Our Ref: BNE230025

Council Reference:	A007098015
Property Location:	21 Riverview Terrace, Indooroopilly QLD 4068
Property Descriptions:	Lot 35 on RP23506
Development Approval:	Development Permit for Material Change of Use – Multiple Dwelling
Applicant:	Tocu Riverview Trust C/- Tocu Group Property Pty Ltd As Trustee

Figure 1 Council Mark-Up on Basement Plan – Landscaping
Source: Excerpt from approved Architectural Plans

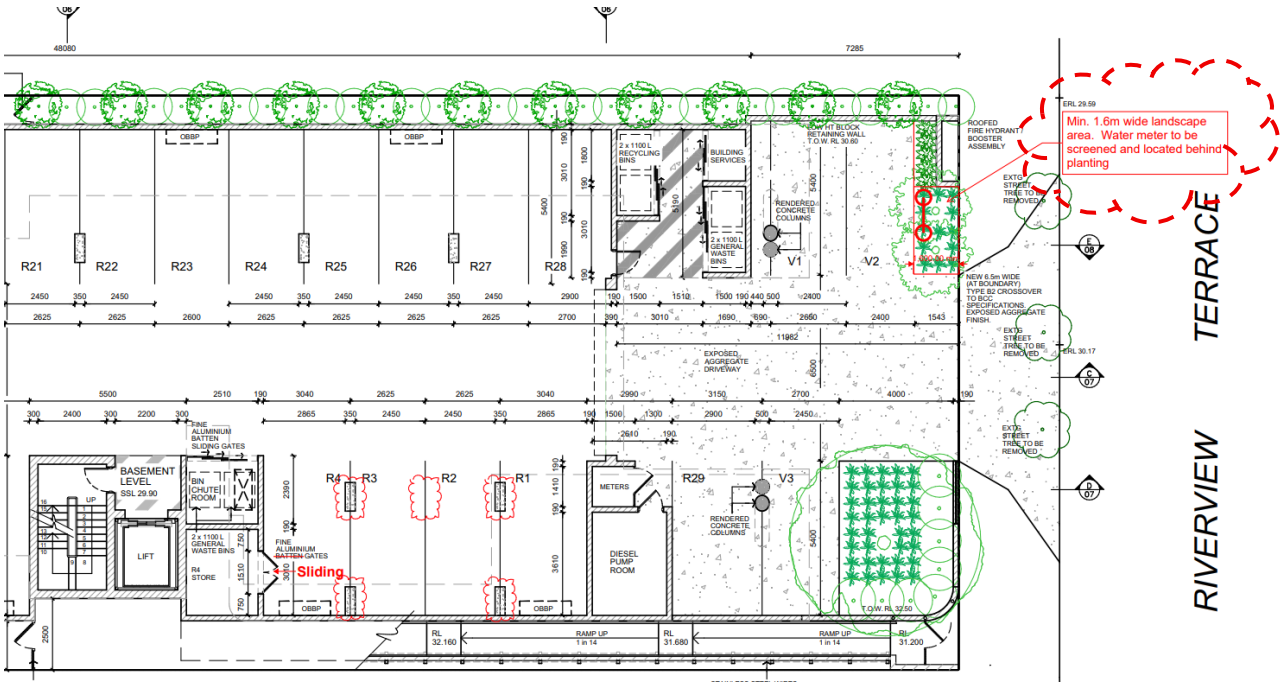
The stamped approved drawings attached to the Decision Notice include amendments made in red by Council which are dated 3 February 2026. While the applicant accepts most of the amendments in red, the applicant disagrees with the mark-up on the proposed Basement Plan (drawing number DA-01 Issue P) relating to the width of the landscaped area at the northern end of the street frontage.

As identified in **Figure 1** below, the garden bed at the frontage was marked up to have a minimum width of 1600mm, when it was shown as 1543mm on the submitted architectural plans.

Due to the location of fixed structural columns on the building, it is not feasible to push the visitor car parking spaces back (west). Therefore, the additional 57mm difference means that one of the visitor car parks will have a width of 2.343m, as opposed to 2.4m, which is not a beneficial development outcome. Accordingly, to avoid having one of these car parks designated as a small parking space, we propose to retain the 1543mm width of the front landscaped area (located at the northern end of the street frontage) as shown on the previously submitted architectural plans and therefore, request Council remove this amendment made in red.
